TO: WECC REMWG
FROM: POUYAN POURBEIK, PEACE®
SUBJECT: PROPOSAL FOR NEW REPC_E POWER PLANT CONTROLLER MODEL
DATE: 8/15/25 (REVISED 9/9/25; 1/23/26)
CC: D. RAMASUBRAMANIAN, EPRI

REPC_E (new model)

Figure 1: REPC_E model (approved specification from September 2025)

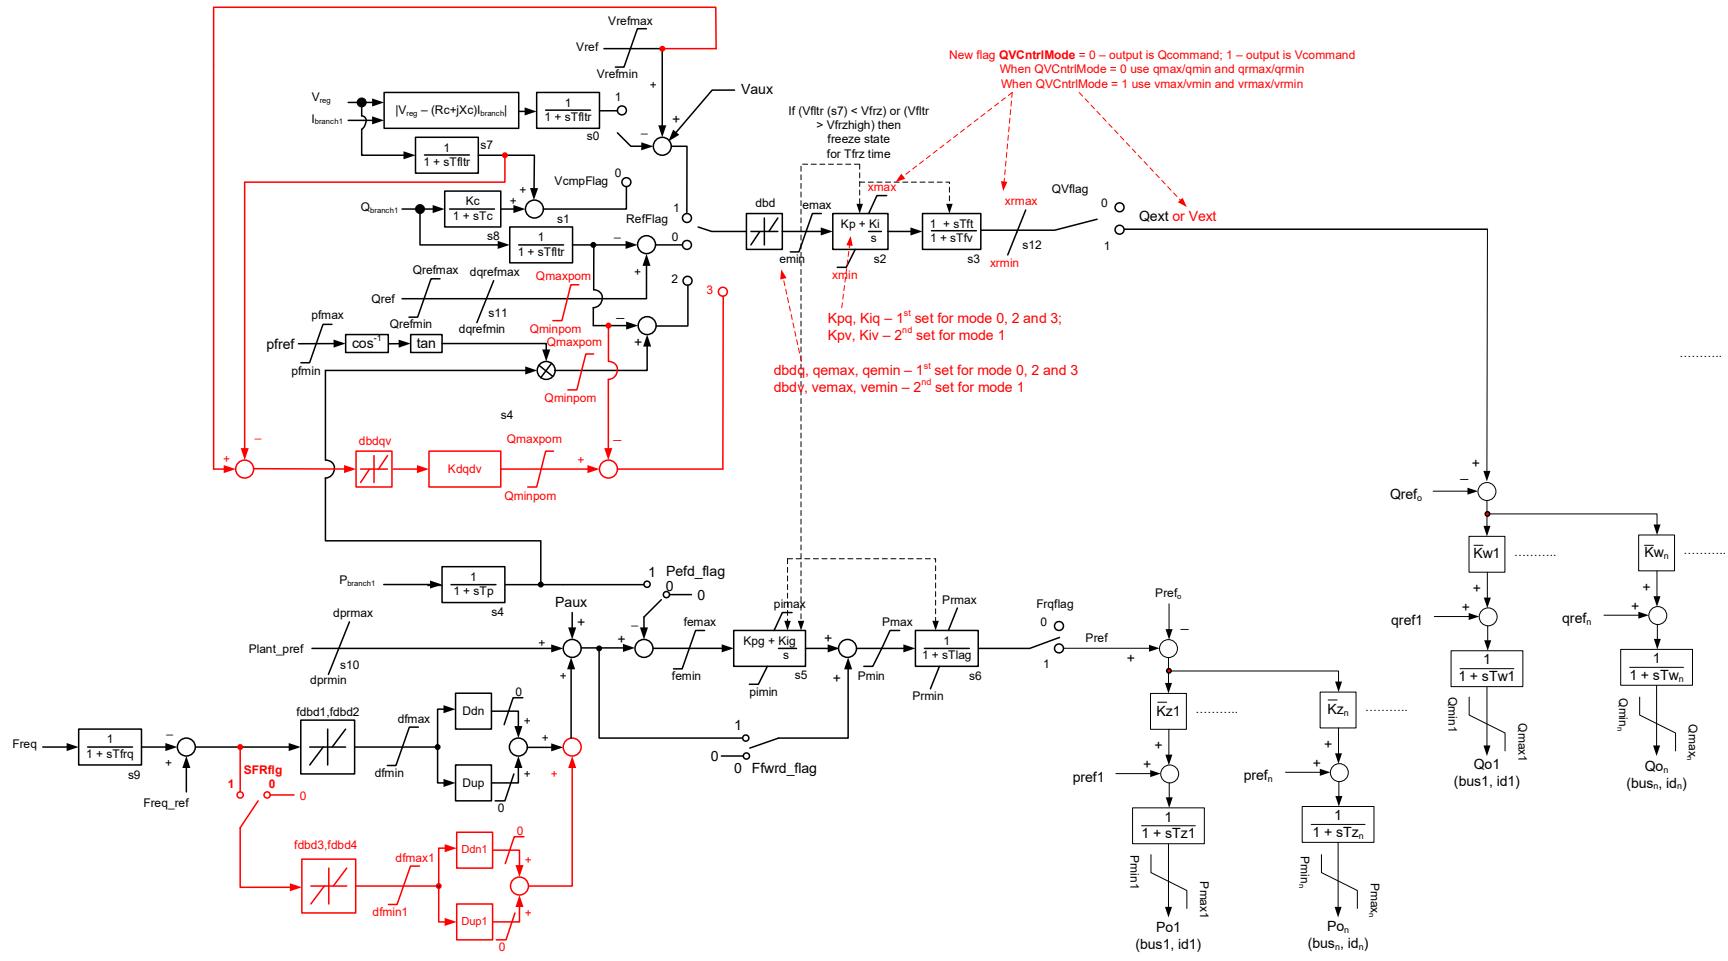
1. **Gains:** adding two pairs of K_p/K_i gains for the reactive controller loop. The model will then automatically switch between the gain pairs depending on the setting of the flag *RefFlag*. See Table 1 and Figure 1.

2. **VQ-droop:** adding a new VQ-droop control option as *RefFlag* = 3. In this control option the voltage error is passed through a symmetrical deadband of $\pm dbdqv$ and then multiplied by a VQ-droop gain $Kdqv$ to get the Q setpoint that is compared with the measured POI branch Q and then fed into the PI control loop.

3. **SFR:** add a Secondary Frequency Response (SFR) loop, which can be enabled/disabled using the new flag *SFRflg*. The SFR control loop has its own deadband (*fdbd2,fdbd4*), error limits (*dfmax1,dfmin1*) and its own droop gains (*Ddn1,Dup1*).

4. **The output limits:** A new flag *QVCntrlMode* should be added so that the user can define whether the downstream aggregated inverters are all to receive a Q-command or a V-command. Then based on that choice the main reactive control loop state is initialized to a Q-command or V-command (*Vext*) and the respective limits (*xmax/xmin* and *xrmax/xrmin*) are set to either the Q limits (*Qmax/Qmin* and *Qrmax/Qrmin*) or the V limits (*Vmax/Vmin* and *Vrmax/Vrmin*). Associated with this addition, this PPC model should be able to interface with all existing generic inverter models, namely: REEC_A, REEC_C, REEC_D, REEC_E, REGFM_A1 and REGFM_B1.

5. ***Qmaxpom/Qminpom:*** Two new parameters, *Qmaxpom/Qminpom* have been added to the model and limit (see Figure 1) the Q setpoint calculated by each of the three (3) different Q-control paths. In this way, this limit can act to limit the max/min Q injected by the PPC at the point of measurement (POM), which is the Q measured on the defined measurement branch. To disable the limits, they may be set to 999/-999.

Figure 2: REPC_E model with proposed new additions as of December 2025 (proposed additions shown in **BLUE** and provided by Tesla)

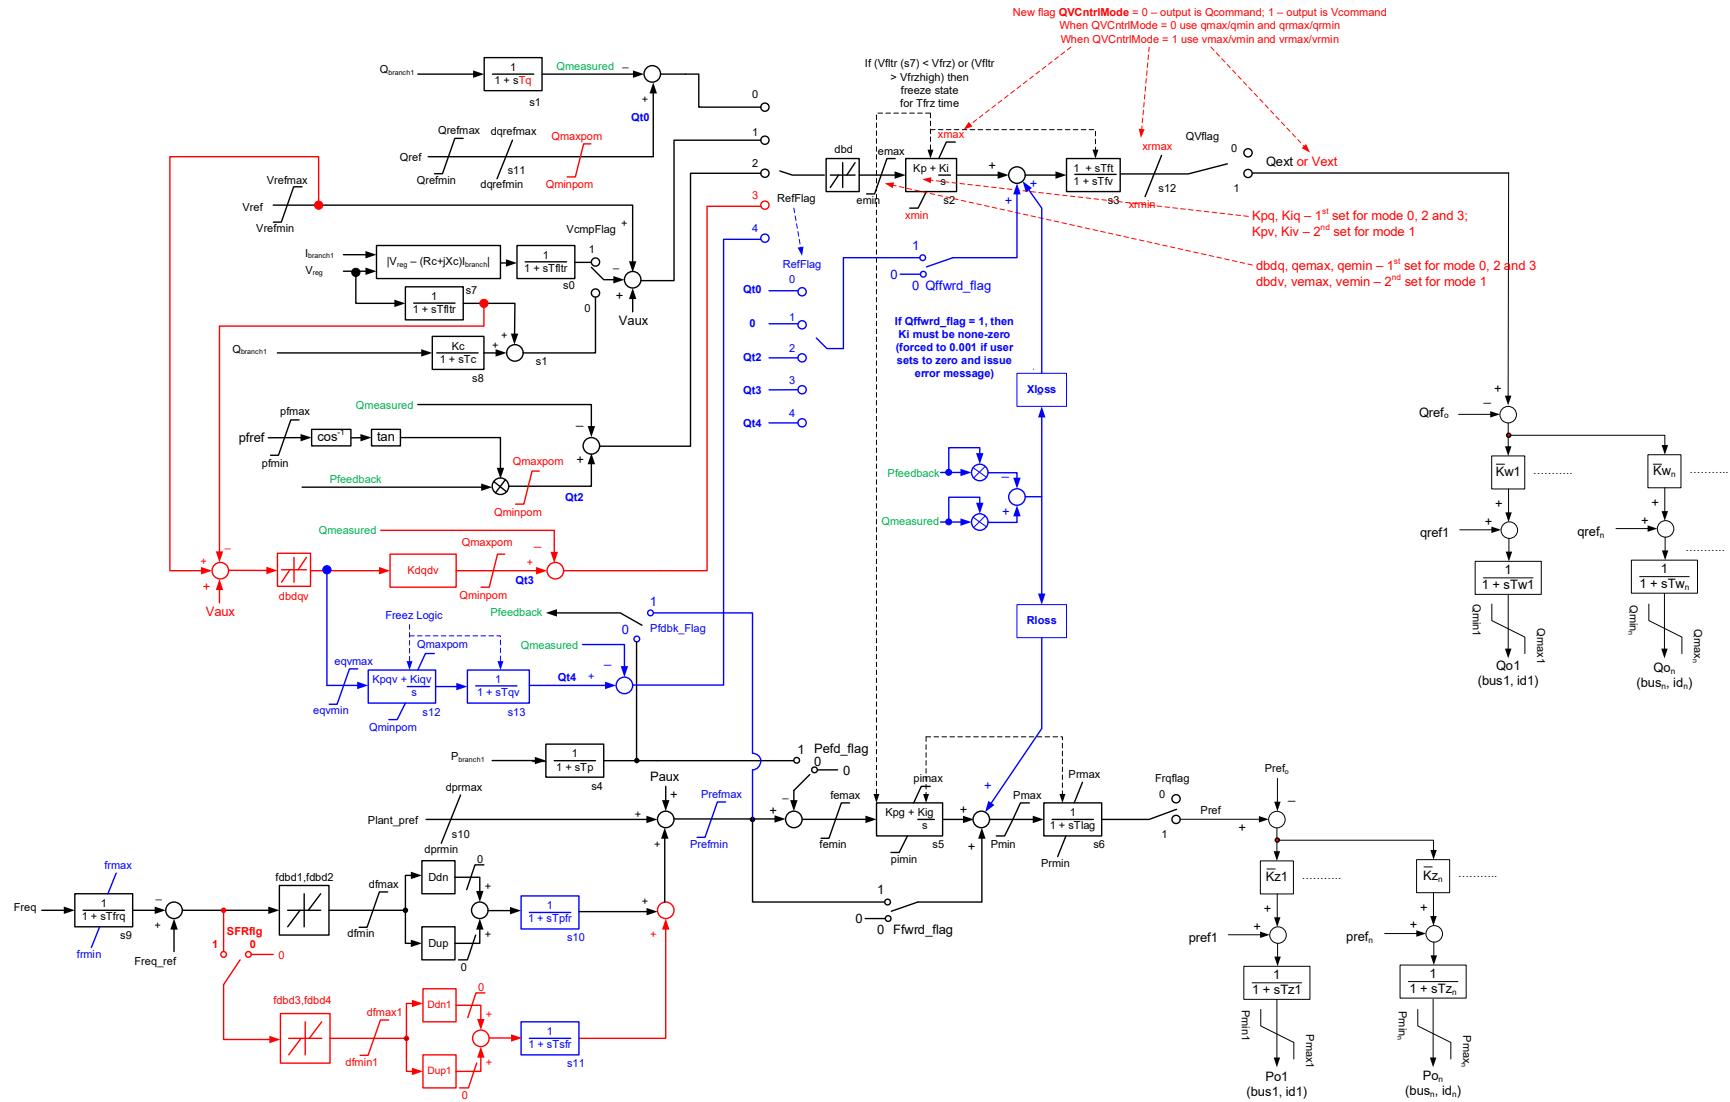
In December 2025, some additional comments were received from Tesla (Sai Gopal Vennelaganti and Fatemeh Sharifi). Those proposed additions are now shown herein in Figure 2. The additions can be briefly explained as follows:

- Adding a few more time constants (to PFR and SFR) and a rate limit to the frequency measurement. These can be used or disabled by the user (i.e. set time-constants to zero and rate limit to a very large number).
- The addition of yet another fourth control path for reactive power, where a double PI strategy is employed (RefFlag = 4)

- The addition of a feedforward path for the reactive power control – it should be noted that if the feedforward path is used, then the main PI controller (K) cannot be zero. If it is set to zero by the user then it should be forced to a small default value (e.g. 0.001) and the user warned of their error.
- The addition of a loss calculation using two parameters (R_{loss} and X_{loss}) which can be set to zero to disable their use. These paths essentially can be used to estimate collector system P and Q losses, and thus adding them into the P and Q control path to compensate for the losses. **Aside Note:** the standard PI loops in essence already do this, and so these additions are not necessary to compensate for losses. However, some vendors may use this strategy so that the PI loop outputs correspond more directly to the P/Q target values.

These additions need to be discussed at the next MVS for general agreement by the whole group. The additions certainly seem reasonable and would add value for greater generalization of the proposed model.
